Barangaroo South  
Stage 1B Basement SSD15\_6960

Submitted to Department of Planning and  
Environment  
On behalf of Lendlease (Millers Point) Pty Ltd

15 October 2018 | 10051

Figure 1 Comparison of proposed changes

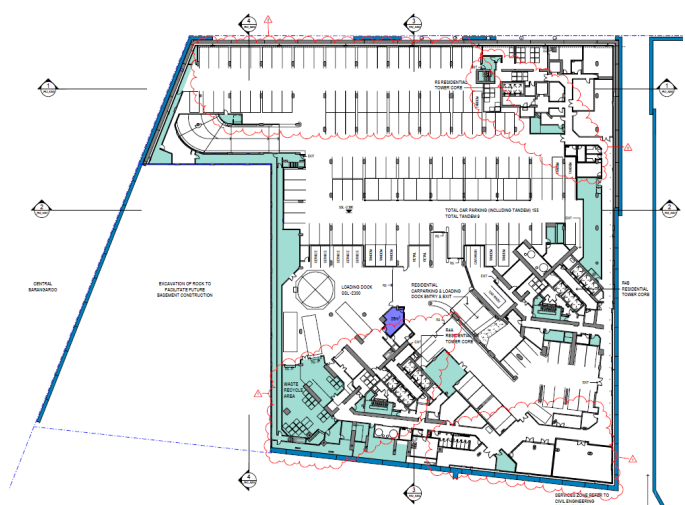
The proposal seeks to reconfigure the Building R5 core located on Basement Level B1. This modification is proposed so that the core aligns with the revised Building R5 design, which will be assessed separately by the Department of Planning and Environment. The revised location of the core results in changes to the R5 residential floor layout design and the location of the lift shaft and other elements on the podium, as illustrated on the Architectural Drawings at **Appendix A**. An extract from the plans showing the revised layout on Level B1 is shown at **Figure 1** below.

Minor plant room and layout amendments are proposed. These include the relocation of structural columns and minor reconfiguration of some back of house facilities and are illustrated at **Figure 1** above and in full on the Architectural Drawings at **Appendix A**. These plant room adjustments also include the removal of the diesel back-up generator approved as part of the original application. This area of the basement will continue to be used for plant and/or storage and back-up power will be provided from alternative power sources within the development, as discussed at **Section 4.4.4**. In addition to this, an indicative area has been provided for fuel cells and microturbines on Level B1. This space is provided should an area for fuel cells and microturbines be required.
